STATE OF CALIFORNIA - DEPARTMENT OF TRANSPORTATION

ENGINEER'S DAILY REPORT
LAN Engineering Consultant

REPORT NO.	225	DATE	July 26, 2007	JUL 26 2007	M T W J F S S (DAY)
NORMAL WORK HOUR:		START: 7:00AM STOP: 3:30PM		WEATHER: OVERCAST/SUNNY	
LOCATION :					
Construction Field Office :			333 Burma Road, Oakland 94607		
Working Drawing Campus Office :			375 Burma Road, Oakland 94607

04-SF-80-13.2/13.9
Contract No. 04-0120F4
{SAS Superstructure}

RFI-706.707 SK-1

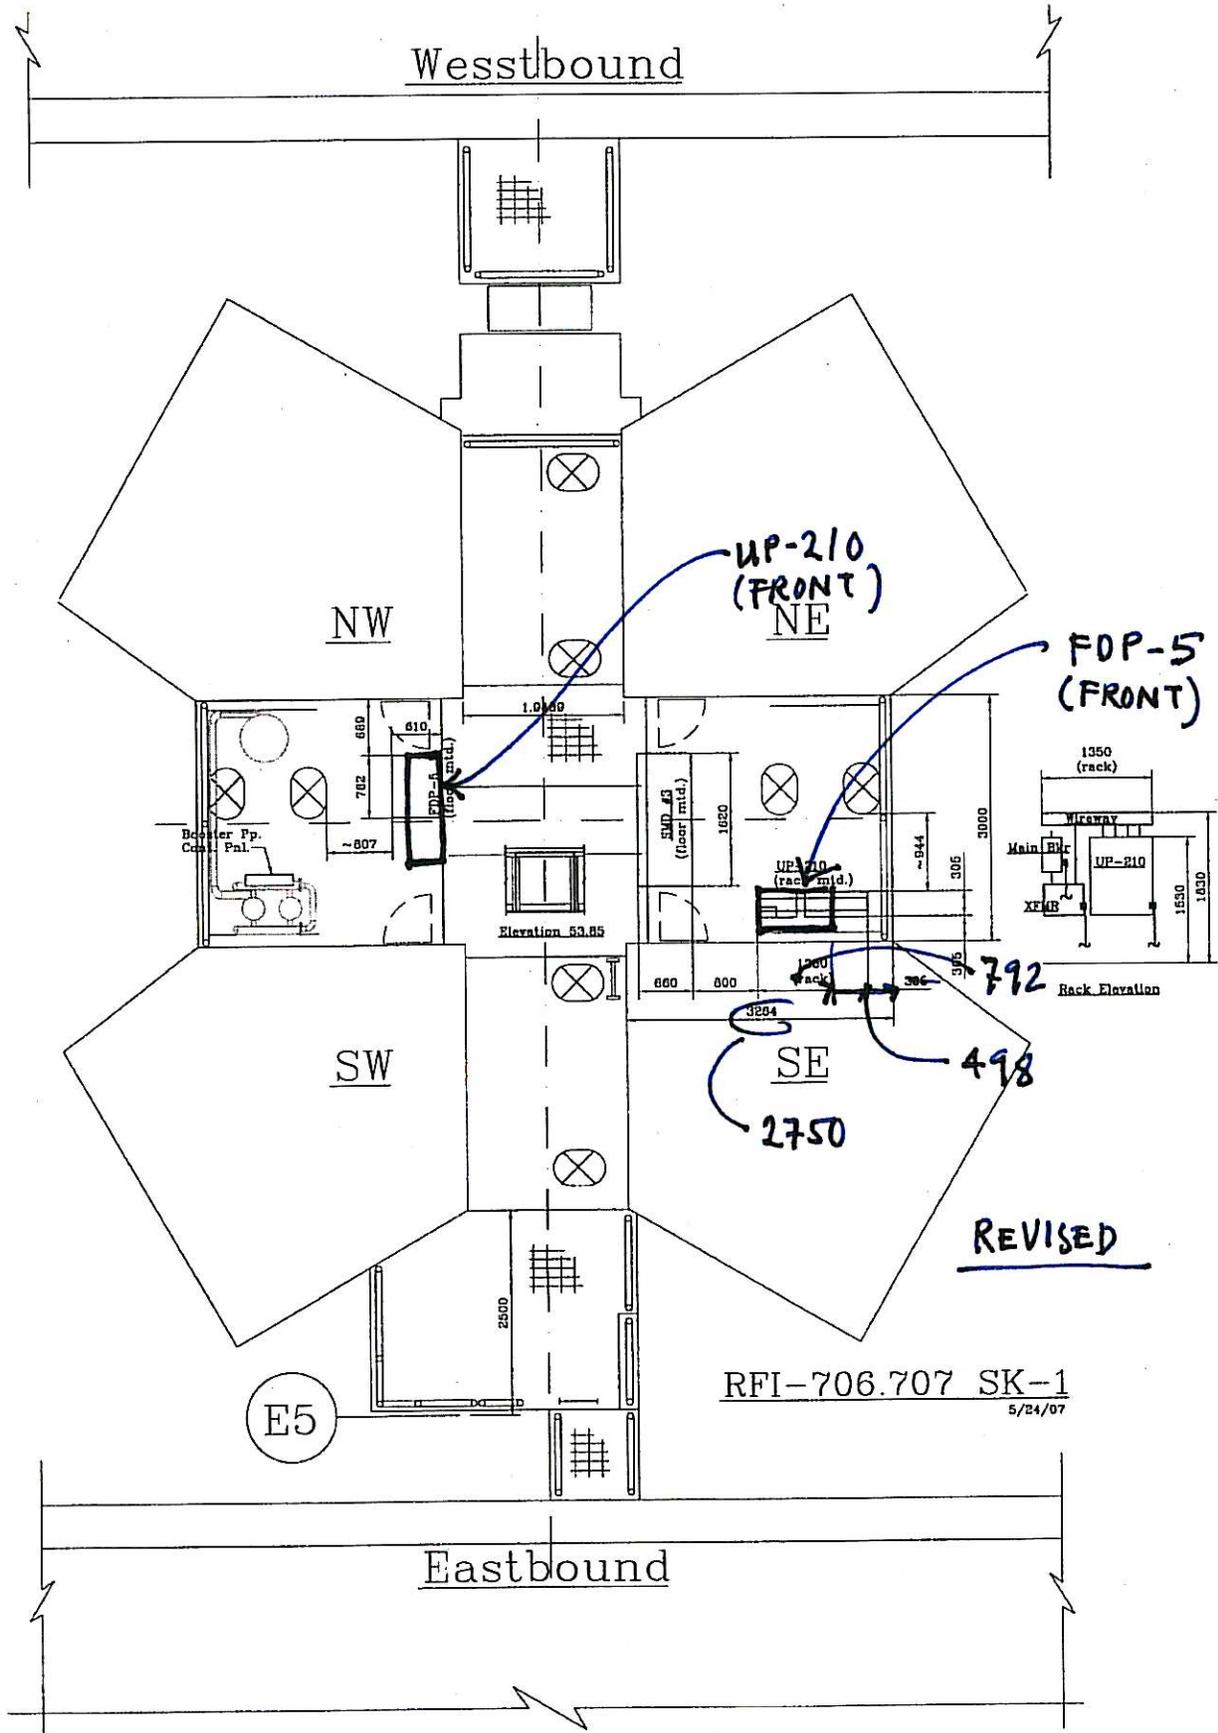
I was outnumbered on yesterday's telecom and realize after (overnight) that what I agreed is going to be "appearance problem".

The reason for not locating the UP-210 behind the railing is because, the UP-210 rack, and all the spaghetti conduits going to the wire way shall be visible from the roadway level at 53.85.

Locating the UP-210 and rack between the NW and SW skin plate, opposite location from the strong motion panel shall hide the electrical installation from the roadway level. In addition, the FDP-5 which is floor mounted equipment (762 wide) maybe a lot smaller when we get all the information which most likely become a wall mount.

So, my conclusion, the revise arrangement is the way to go. Conduit rerouting, to avoid crossings is not a monumental task to change but the "appearance" shall be forever on the bridge.

My concern will be the following:

1. The conduits should not be visible from the roadway, don't want to deal with aesthetic issue.
2. The UP-210 be accessible for service personnel (door can be opened).

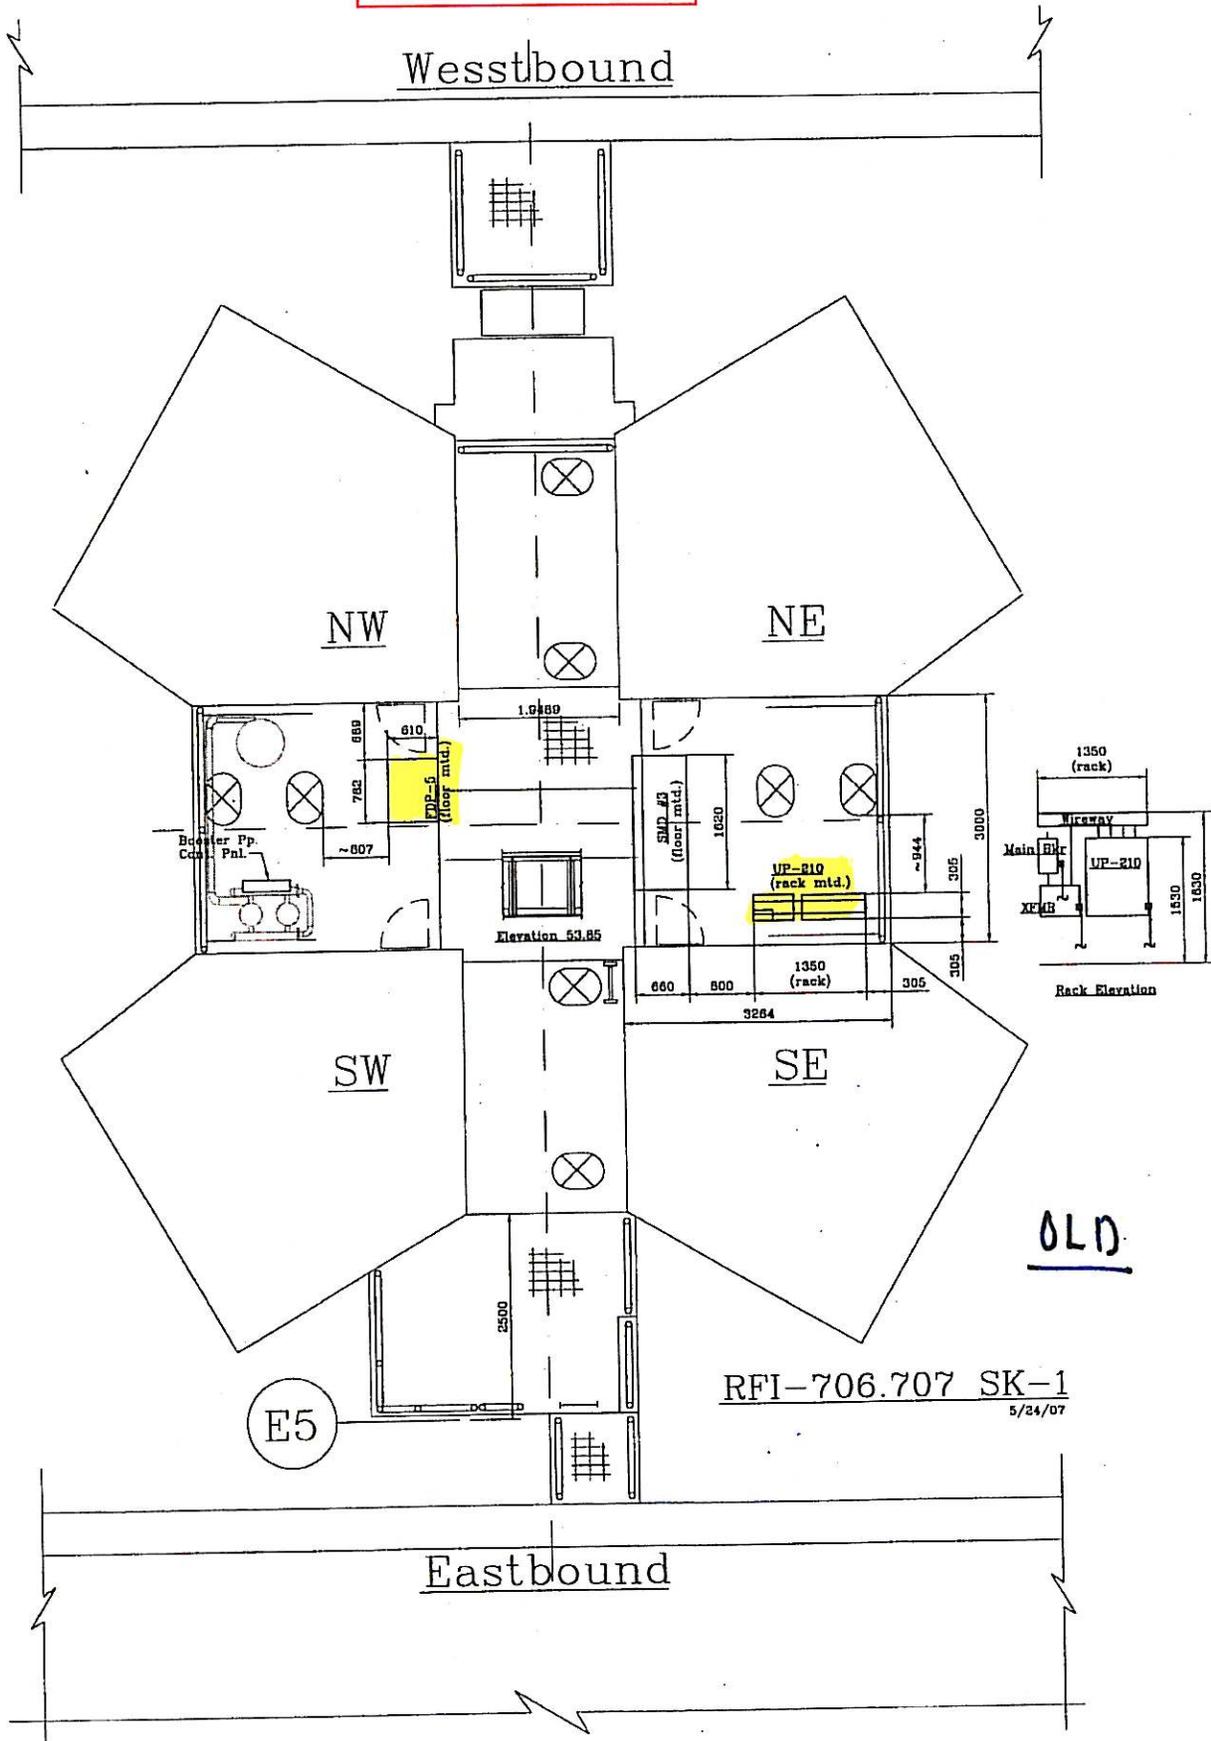
Please work the following with the response to RFI 707:

- Contrary to the first statement, tower skin penetrations and attachments changed due to elevation changes for conduit routes. Equipment relocation to different quadrants resulted in previously run north-south conduits changing to east-west conduits.

- Utility panel UP-210 submitted separately as main breaker, transformer, and panelboard per the 4th paragraph (Submittals 174, 175, 176) has not been approved. It was stated in the 7/10/07 MEP meeting that a re-design of UP-210 is in progress.

- Pullbox 914x762x406 sized per NEC code 314.28, mounted on the SW-E plate, has been added in lieu of PB-2D and PB-3A deleted by the 5th paragraph, as the multitude of large conductors can not be routed through the 8x8 wireway. Additionally, Circuit A-3057-1 pier lights has been deleted from Conduit #3281 carrying sump pump conductors from UP-210. This circuit has been added to Conduit #3364 routed direct to the SW-A face.

- Sketch RFI-707-7.07 SK-1 lays out UP-210 using an incorrect dimension of 3264 mm for the SE-A plate. Please issue a corrected layout using 2750 mm for the A plate.

To avoid further re-work of the electrical information for the tower shop drawings, please consider future responses that keep equipment in the same quadrant without raising elevations.

TRANSFORMER TYPICAL FOR PANELS BARD'S
 UP-104, UP-107, UP-204, UP-205, UP-206, UP-207
 LP-219, LP-220, LP-221, LP-222, LP-223
 UP-105, UP-106, UP-108, UP-208, UP-210

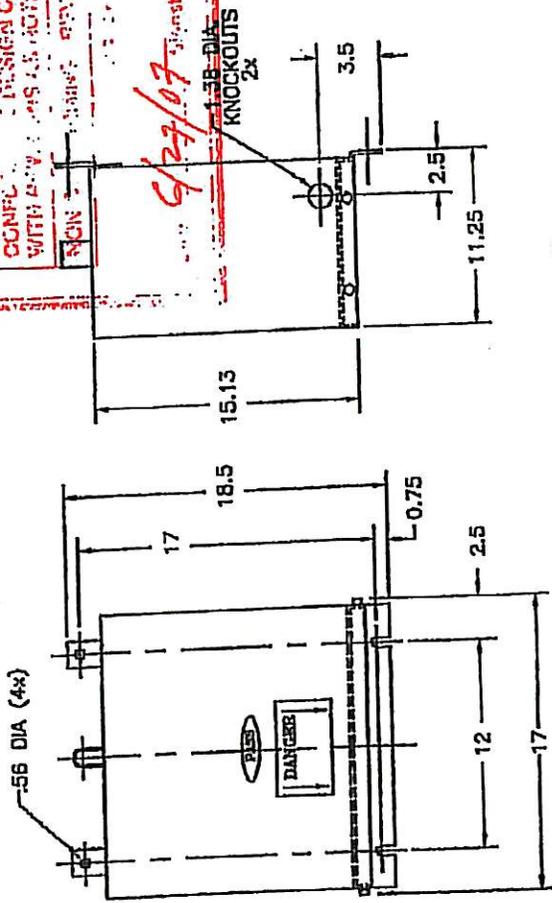
*ITEM 2 ARE NOT INCLUDED IN RFI-451.
Excluded from review. Redesign pending.*

TRANSFORMER TYPICAL FOR PANELED HP-210-1A, UP-210-1B

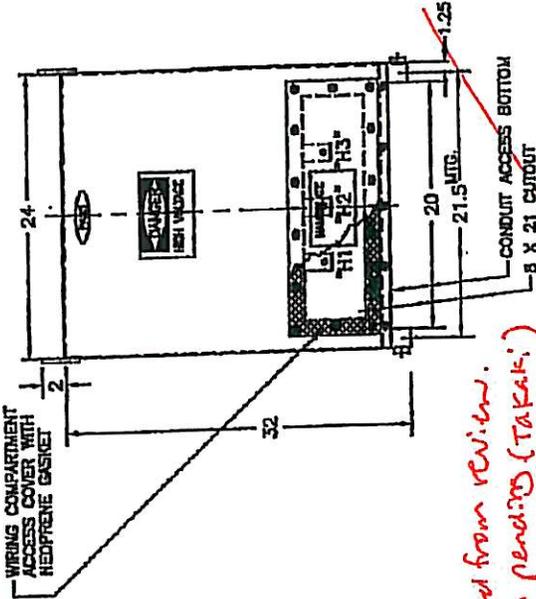
Excluded from review. (Design pending (Takaki))
